ADDENDUM NO. 3

Williams Brice Stadium Plaza Site Upgrades – Construction

State Project No. H27-6104-MJ-B

FRP-01

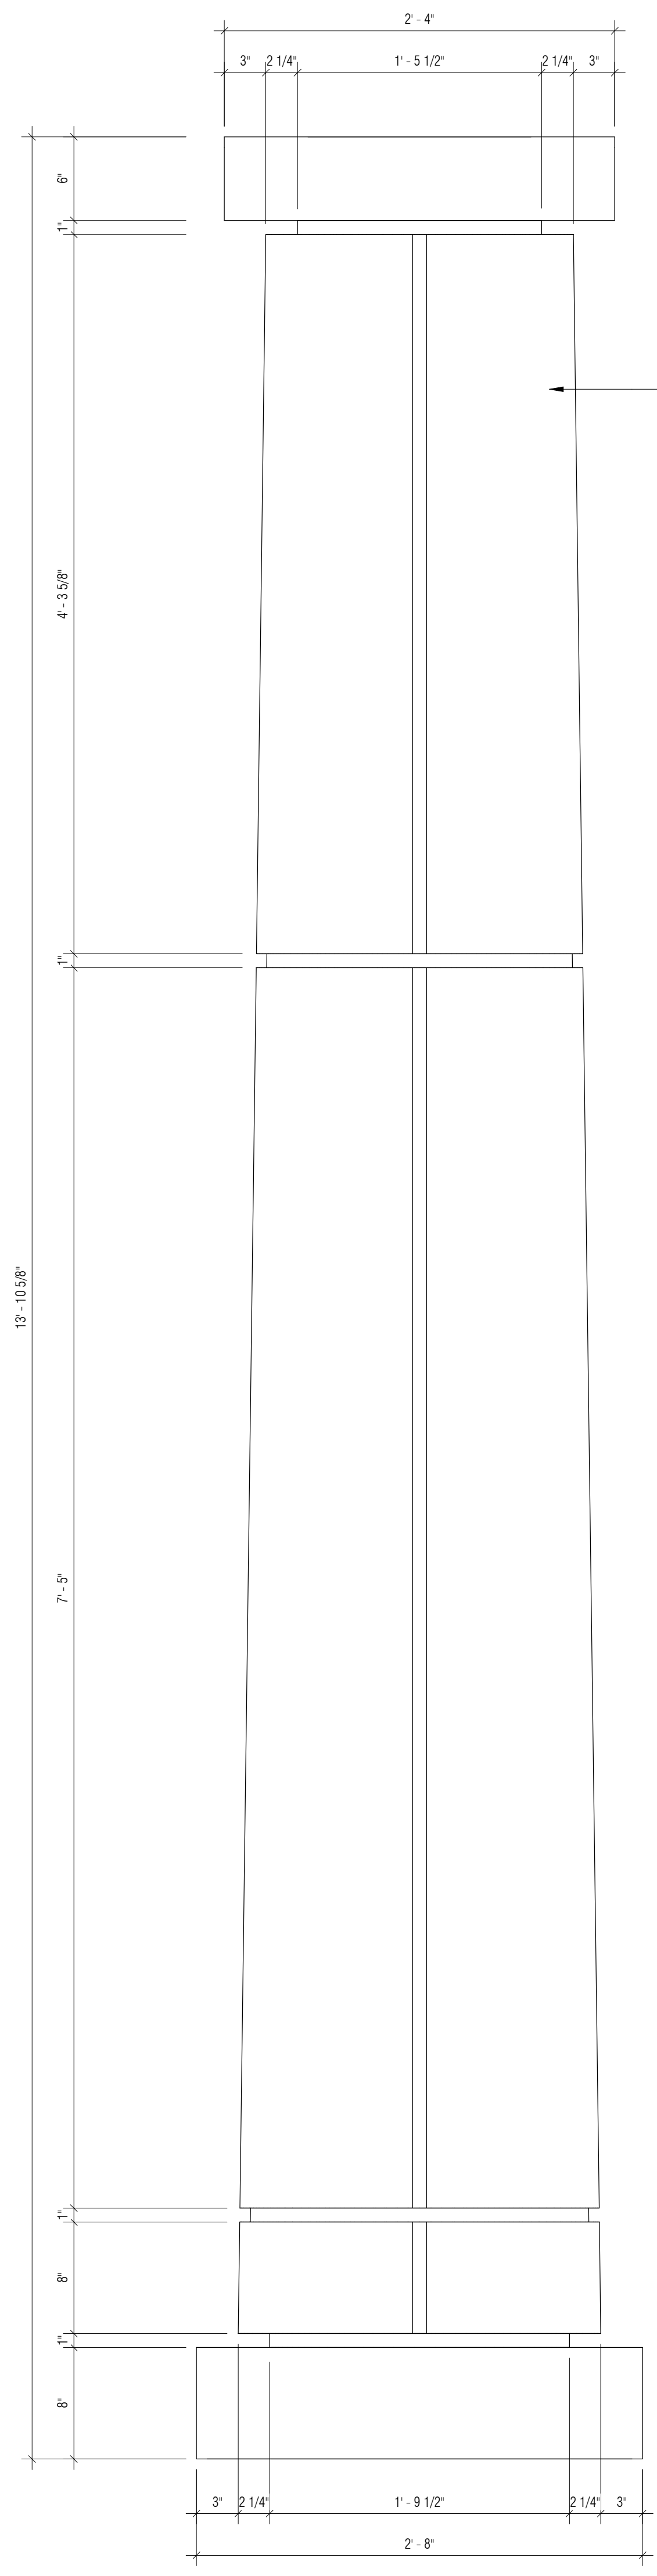
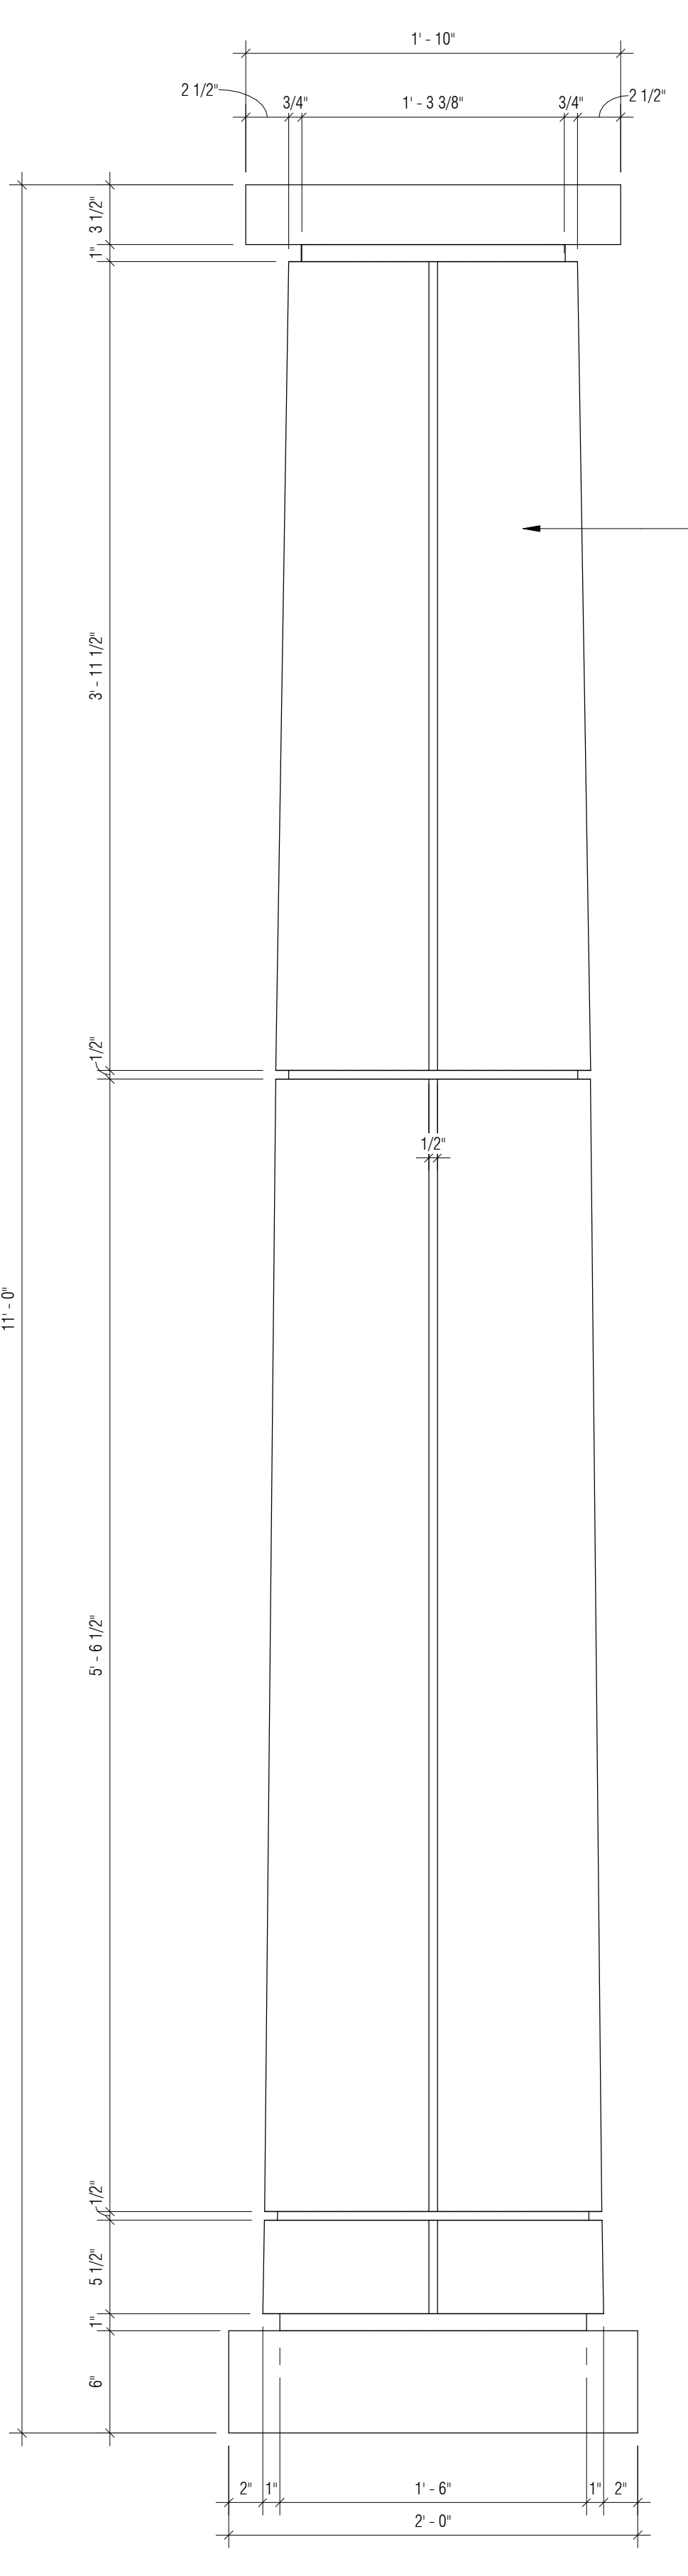
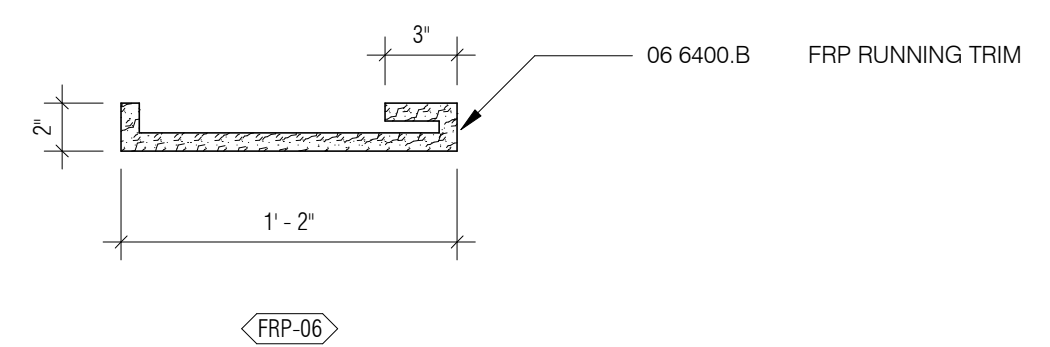
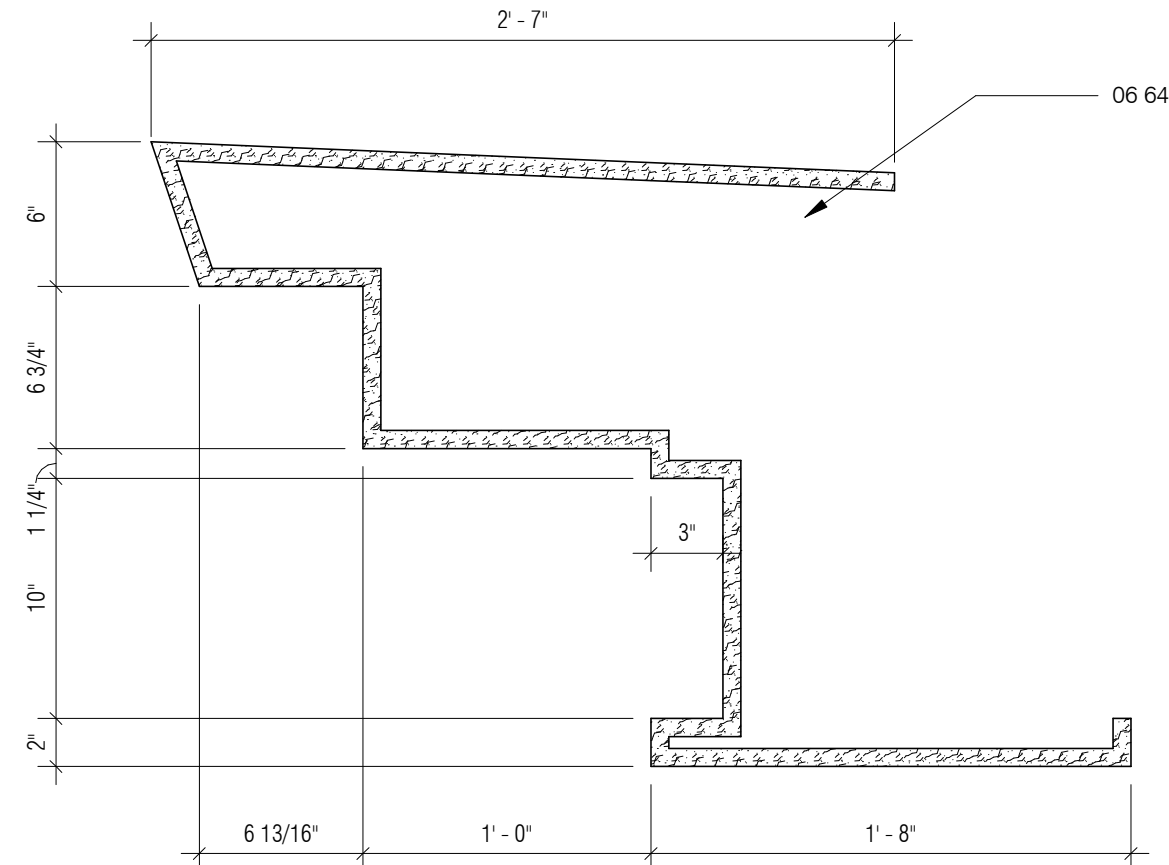
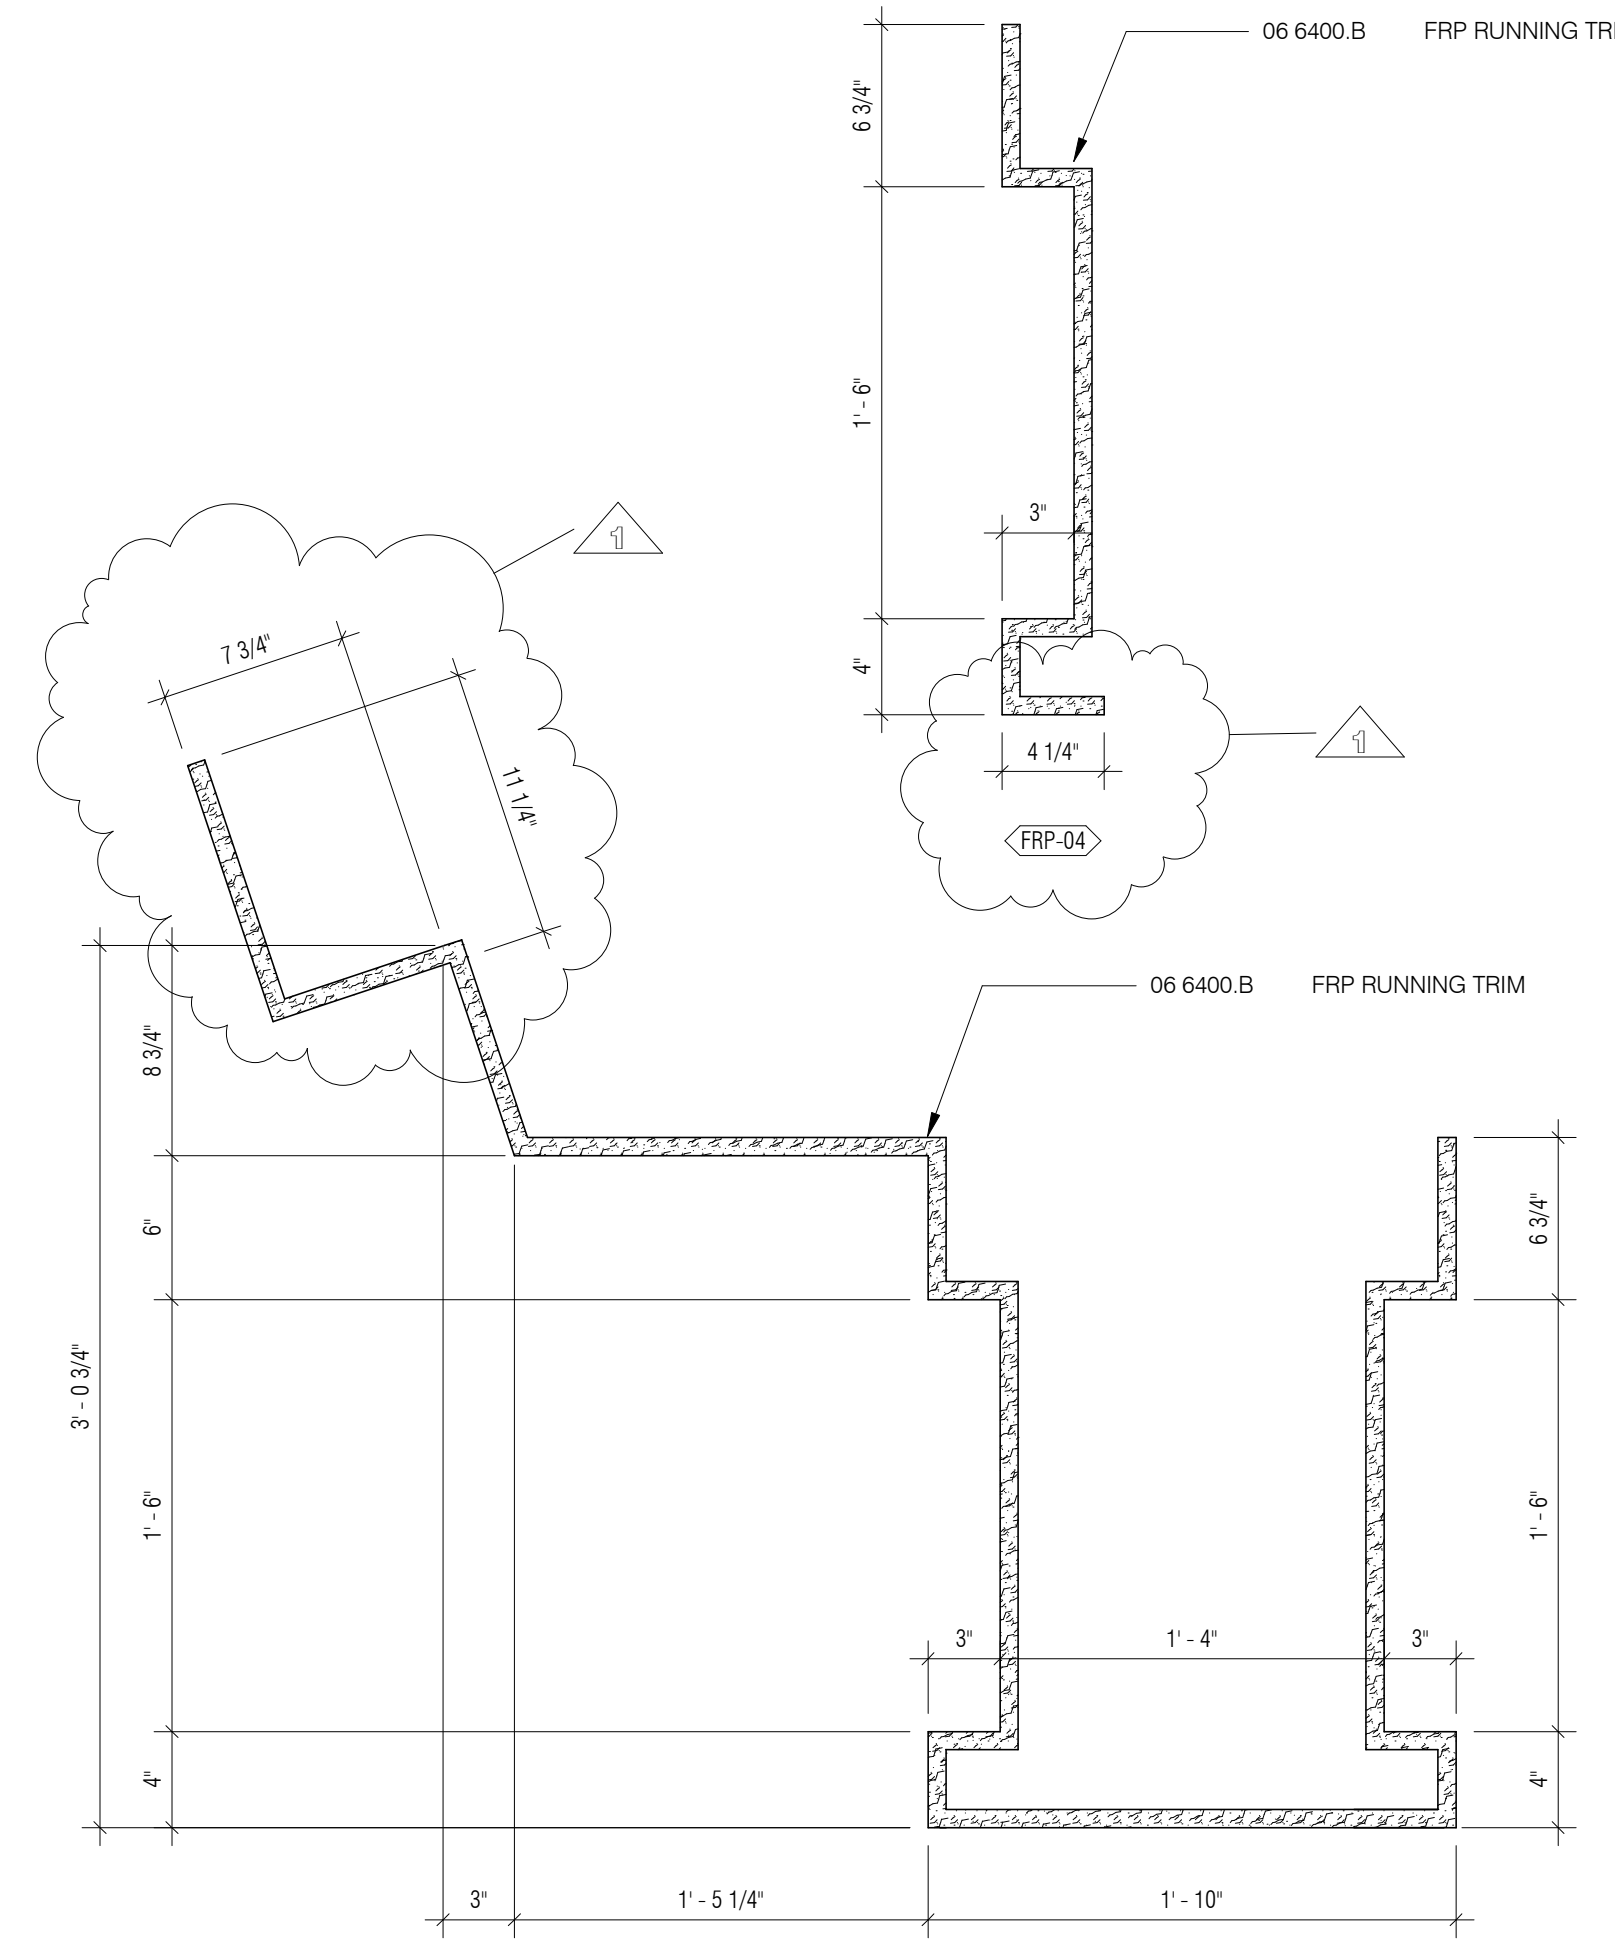
2. Drawing **“Roof Plan & Details” A110**, modify the typical roof details for the new R-value per the attached revised drawings.
3. Drawing **“FRP & Cast Stone Details” A161**, modify the FRP profiles per the attached revised drawings.
4. Contractors shall use plan sheet L200 and the legend contained therein for information pertaining to all concrete pavement locations and thicknesses. The Civil details and plans cover the asphalt pavements in the parking areas located just east of the Gameday building and on the south side of Key Road.
